DEPARTMENT OF ECOLOGY  
INSPECTION REPORT

TO: Files, Dan Cargill  
DATE OF VISIT: 5/28/86  
NEW INDUSTRY:

FACILITY: Duwamish Shipyard Inc.  
ADDRESS: W. Marginal Way  
CITY: Seattle ZIP 981 COUNTY: King Ph.No.

scrap  
barrel  
storage

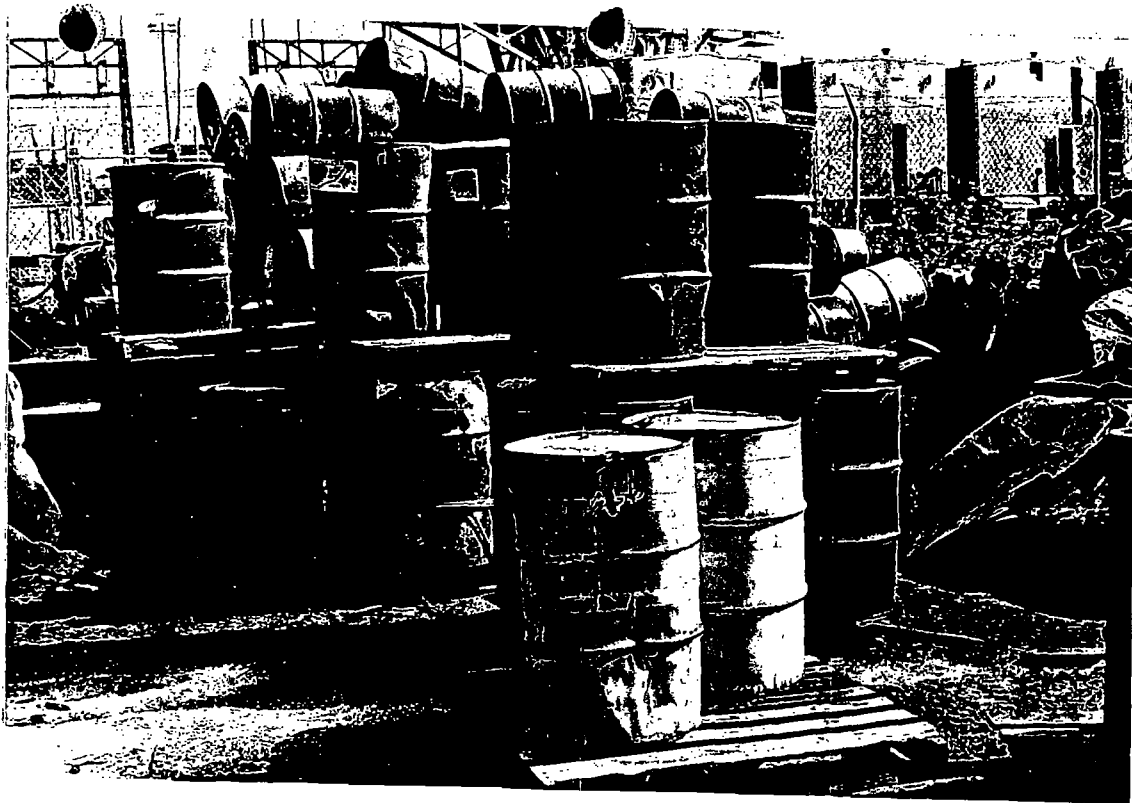
Barrel inventory was dated May 22 & 23, 1986. The barrels are now segregated and fewer in number. The railroad car is gone. Three tanks from or for the Aleutian Mistress (10'x6'dia.) are in the back barrel storage area. There is not yet concrete or containment in this back barrel storage area. The barrels from the railroad loading dock have been removed.
